Project Name:	Project Marvel – Concept Design Review, Air Quality
Reference:	23.1126.FR3V1
Status	FINAL

The AQIA was submitted with the SSDA. While no air quality issues were raised in submissions at the Response to Submissions (RTS) stage, changes to the built form were required in response to other matters. A summary of these changes is provided in Figure 1.

Figure 1 Summary of changes to the built form

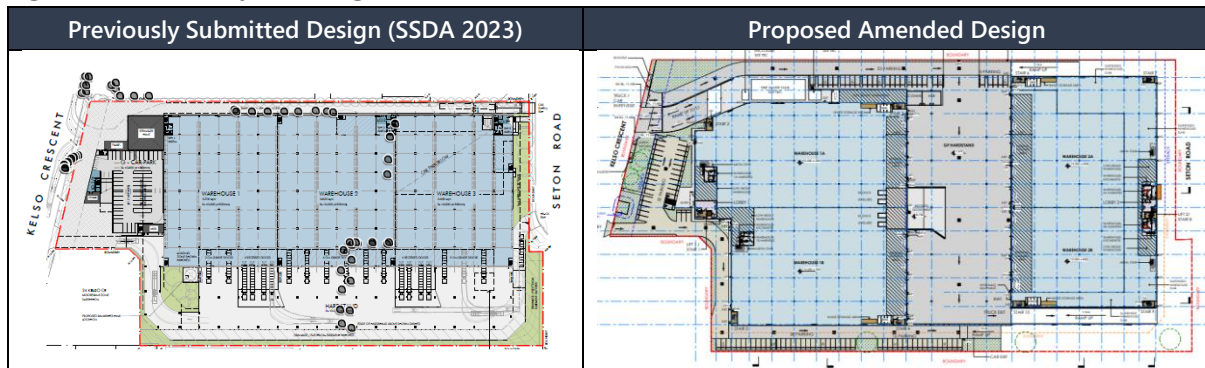
As identified in Section 1, traffic generated due to the proposed warehouse operations is the limiting variable in dispersion modelling assessment. The updated traffic data and the relevant changes are shown in Table 3.

As presented in Section 2, changes to the built form result in a reduction in the predicted AM peak and daily total traffic movements, with a slight increase observed in PM peak traffic movements. These changes would also lead to minor adjustments in the modelled source locations. However, the changes in emission source locations due to the altered built form are not expected to materially affect the conclusions of the original AQIA, given the minor incremental impacts predicted during the operational phase.

Overall, considering the insignificant incremental impacts from operational activities, the minor changes in modelled variables are unlikely to alter the report findings or significantly affect the predicted short-term or long-term pollutant concentrations. Consequently, remodelling the Project operations for the proposed amended design is not considered to be warranted.
